ARTA Roadways Drainage Meeting

December 5, 2023

Objective: The purpose of this meeting is to discuss impacts on ARTA projects in various stages of development and the impacts from the November 9, 2023 Issuance of a new Drainage Criteria

PROJECT STATUS - 12/4/23

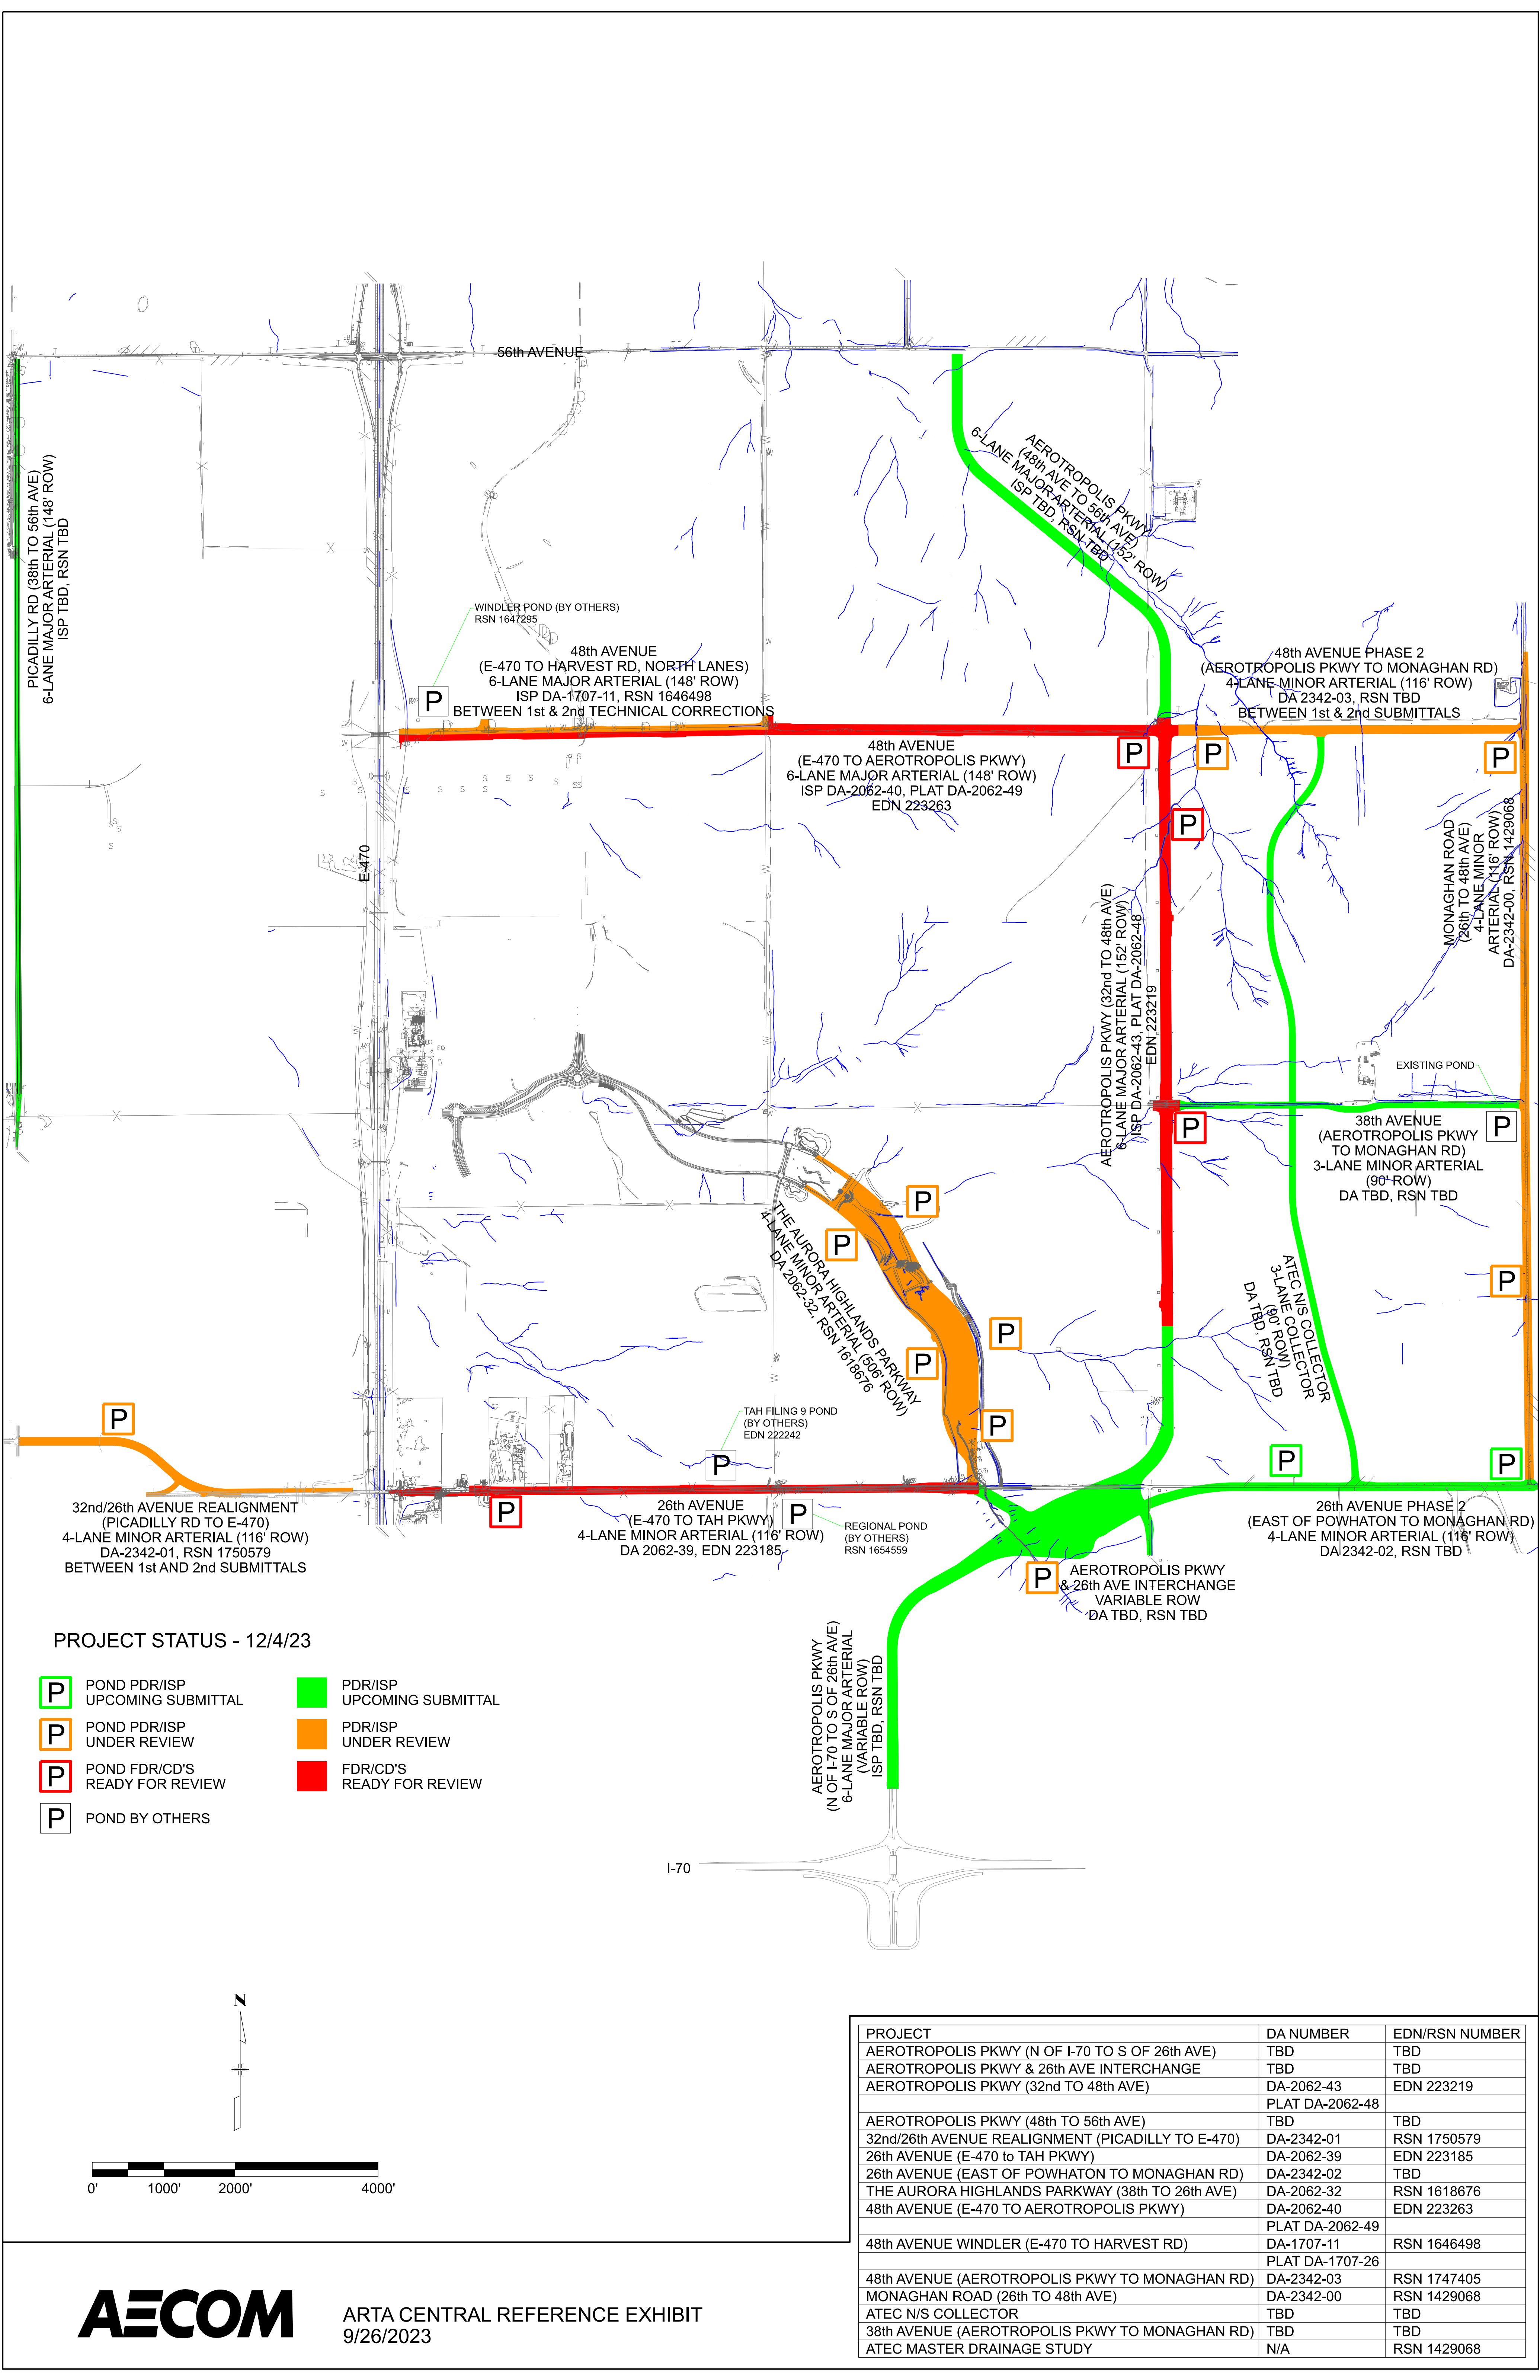
- ARTA reviewed the status of current projects in review by the City (see attached map)
- Projects with approved PDRs and ready to submit CDs (Red)
 - 26th Ave E-470 to The Aurora Highlands Pkwy

- Aerotropolis Pkwy 32nd Ave to 48th Ave
 - 48th Ave EB E-470 to Aerotropolis Pkwy, WB from Harvest Mile to Aerotropolis Pkwy
- Projects in the ISP/PDR submitted at least once (Orange)

- 32nd to 26th Realignment (Received 1st review comments, addressing)
 - The Aurora Highlands Pkwy (In review by City, 4th review, CLOMR in review by City) only one with permanent ponds

- 48th Ave WB E-470 to Harvest Mile (Former Windler, 4th Review addressing comments)
 - 48th Ave Phase 2 (Aerotropolis Pkwy to Monaghan Rd) Received 1st PDR comments and addressing)

- Projects in development (Green)
 - 26th Ave Phase 2 (Aerotropolis Pkwy to Monaghan Rd)
 - Aerotropolis Pkwy 26th Ave interchange
 - ATEC N-S Road (26th to 48th)

- ATEC 38th Ave (Aerotropolis Pkwy to Monaghan Rd)
 - NB Picadilly Rd (38th Ave to 56h Ave) Pre-Submittal Meeting schedule for 12/21 various approved reports, studies, and plans)
